PJM Tier I Inventory & Forecasting

*Updates to Eligible Supply, Capacity Factors, and Addition Assumptions
in response to PRRP RPS Study Group report by Exeter Associates*

June 8, 2018

MDV-SEIA

Figure IV-1. Non-carve-out Tier 1 Generation Required by the RPS in Maryland and PJM

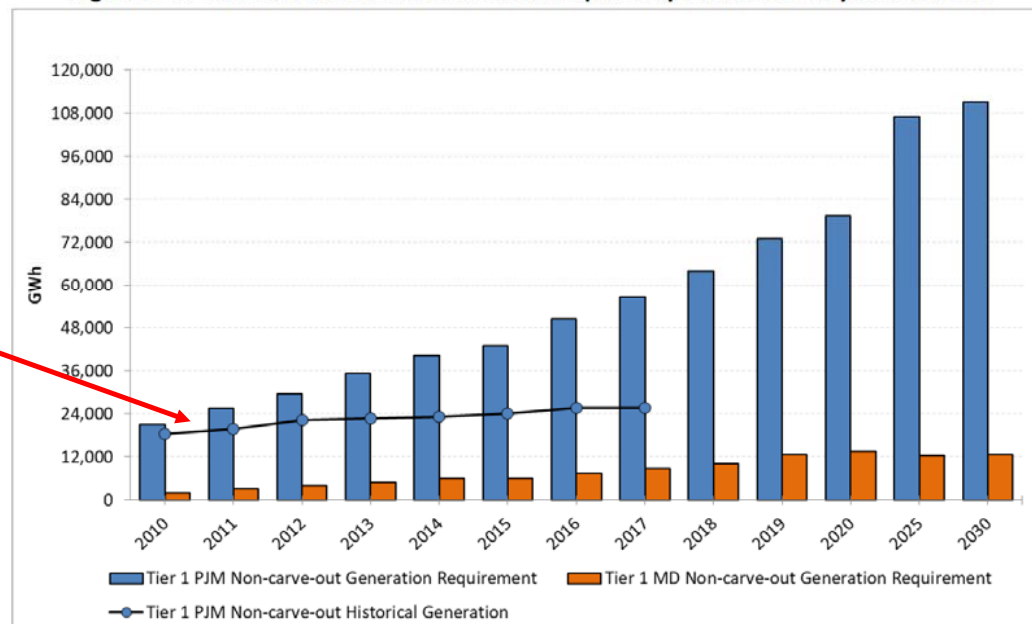
- Figure IV-1 from the Exeter report shows that the Tier I PJM Non-carve-out Historical Generation (in GWh) is well below the Tier I PJM Non-carve-out Generation Requirement. This represents an “undersupplied” market that would be trading close to ACP levels.

This line represents Exeter’s estimate of Tier 1 supply (i.e. Exeter’s “Tier 1 Inventory”).

According to this estimate, Tier 1 demand (shown by the blue bars) far exceeds supply, and PJM Tier 1 RECs are under-supplied.

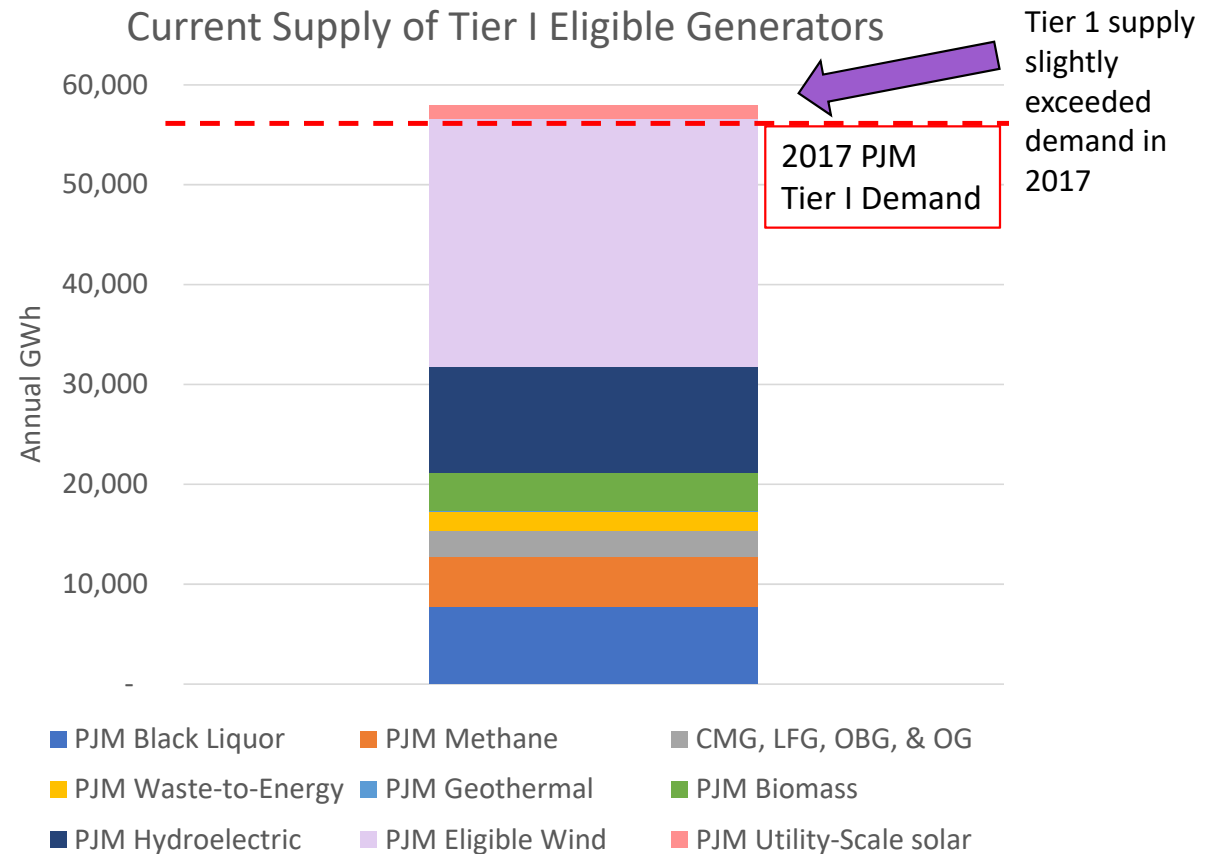
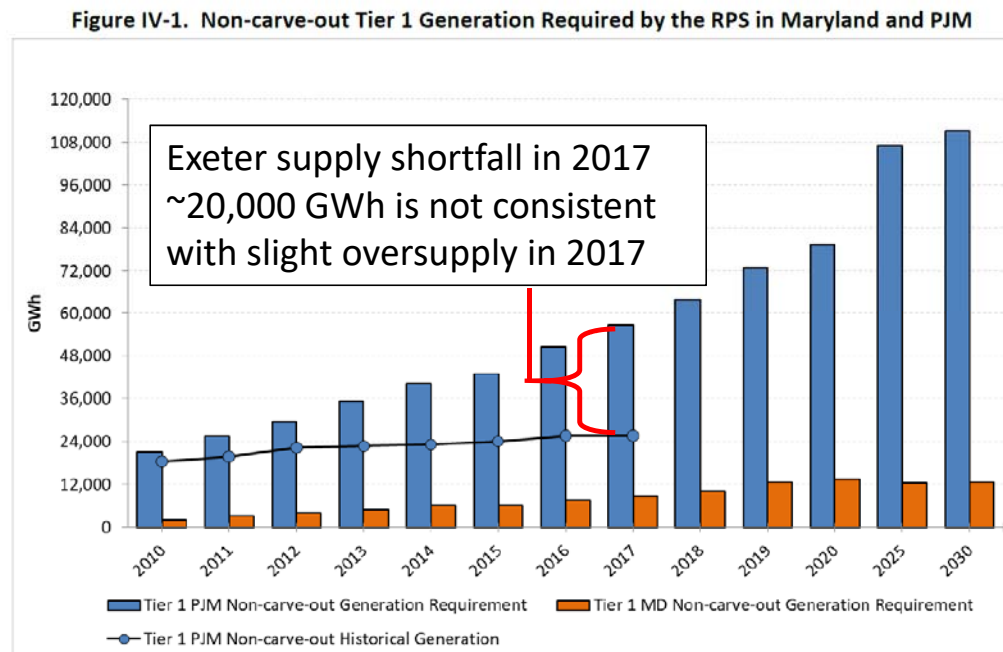
- Using Exeter's aggregate RPS demand tabulation:
 - 2017 PJM Tier I demand: **55,650 GWh**
- MDV-SEIA's PJM Tier 1 inventory methodology estimates slight oversupply in PJM in 2017
- This is consistent with stable PJM Tier 1 prices in 2017 in the \$6-\$12/MWh range vs. ACPs in the \$30+ range
- This observation is inconsistent with Exeter's under-supply estimates which show significant undersupply in 2017

Exeter's approach concludes that the Tier I Generation Requirement (at ~55,000 GWh) exceeds the Historical Generation (at ~33,000 GWh). If this were the case, Tier I REC prices would have been at or near ACP levels in 2017 across PJM, which was not the case.

Addition Rate Assumptions - Wind

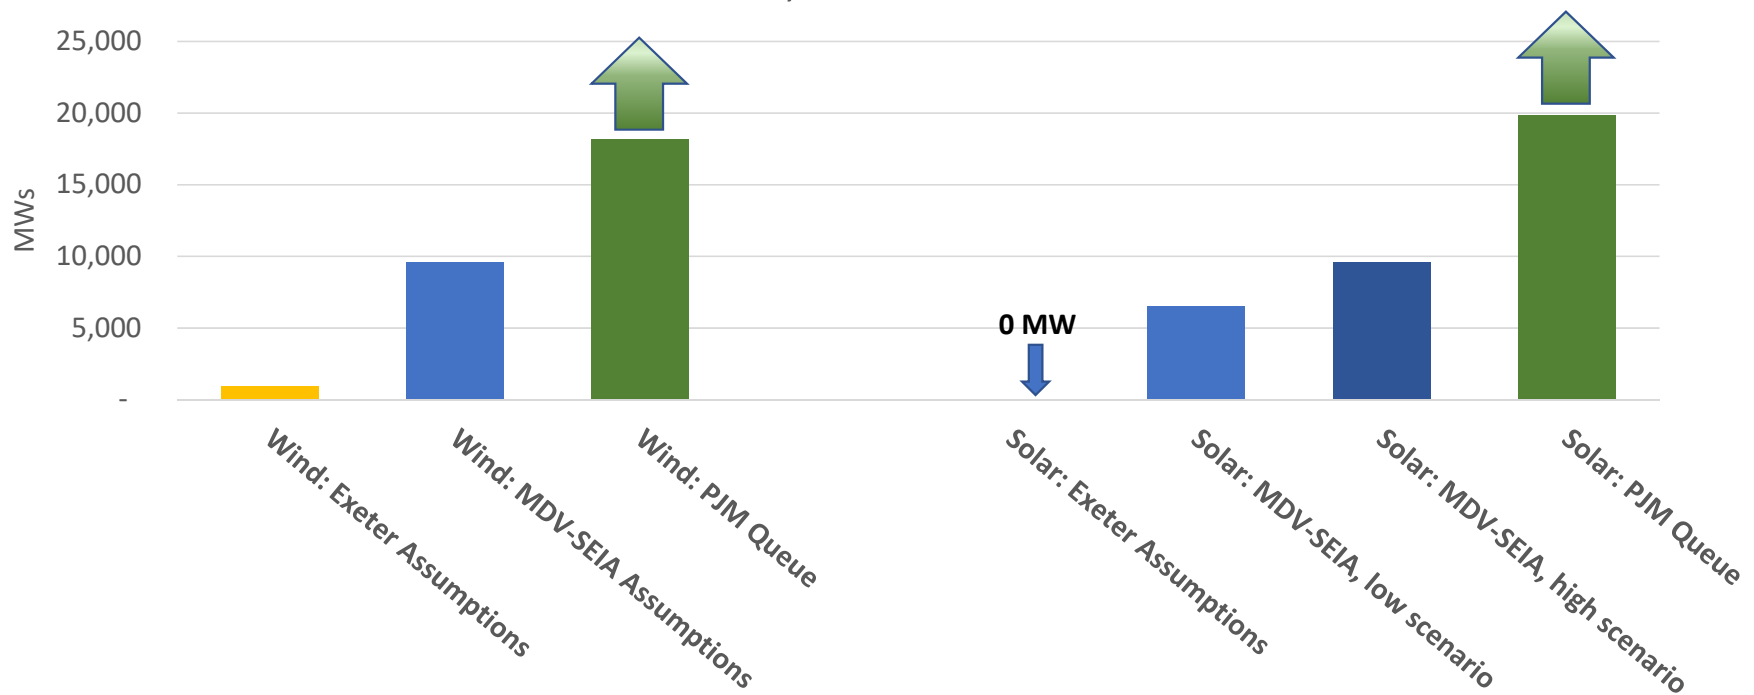
- Exeter's analysis assumed 940 MW of total wind additions from 2018-2030 (or **78 MW/year**)
- Historic additions over the last 10 years have been roughly **800 MW/y** year in PJM
- The PJM queue for wind projects under development currently shows ~18,000 MW of wind projects under study, engineering, or construction in PJM
- It is reasonable to assume that there will be a continued addition rate of 800 MW/y of PJM Tier I eligible wind over the next decade

Addition Assumptions: PJM Tier I Eligible Wind and Utility-Scale Solar, 2018-2030

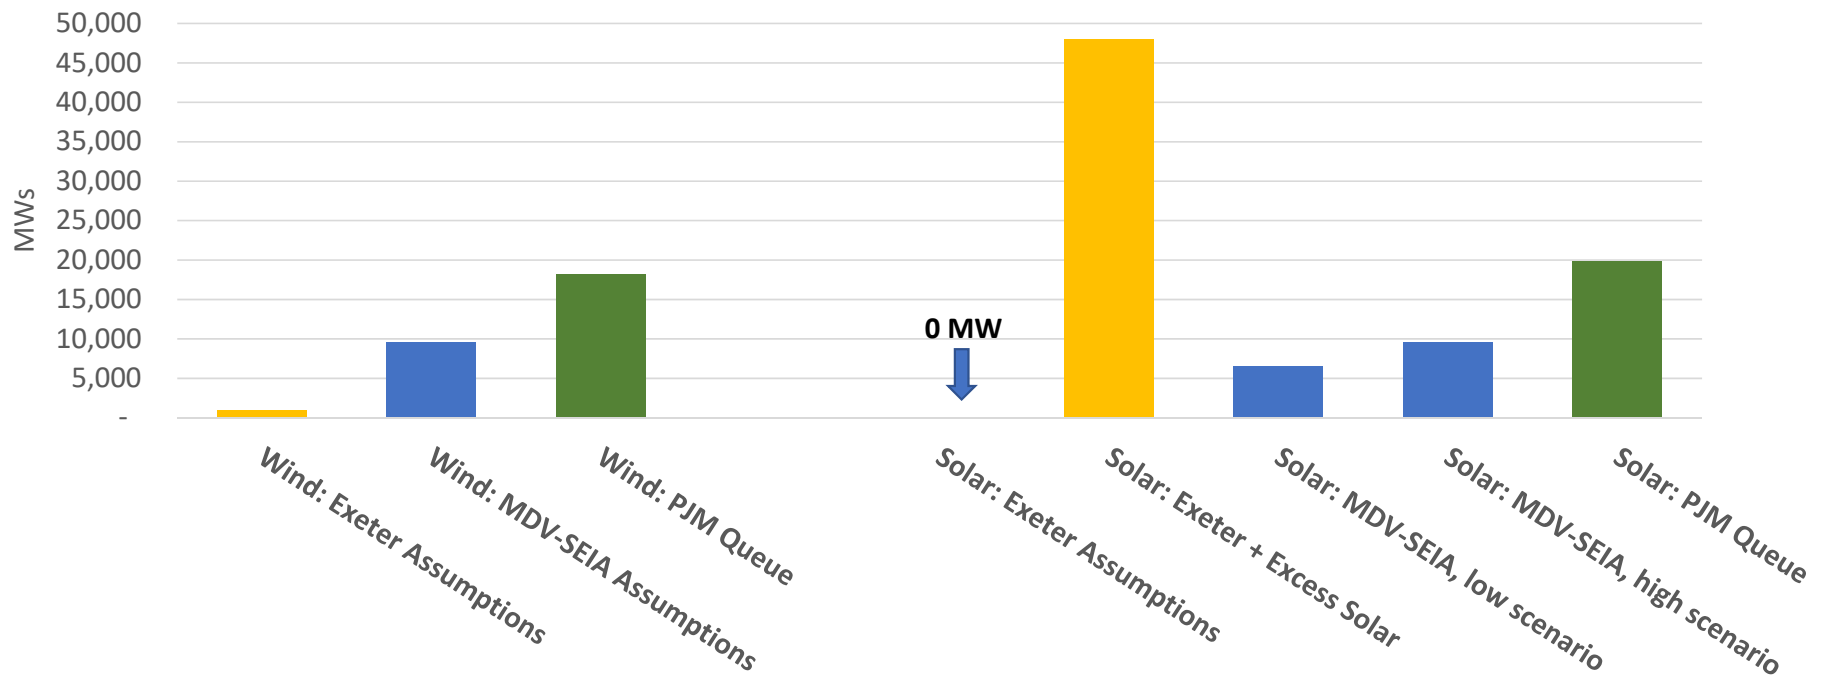
For Undersupply Narrative to Hold, Expected Tier 1 Solar Additions Must Be Ignored
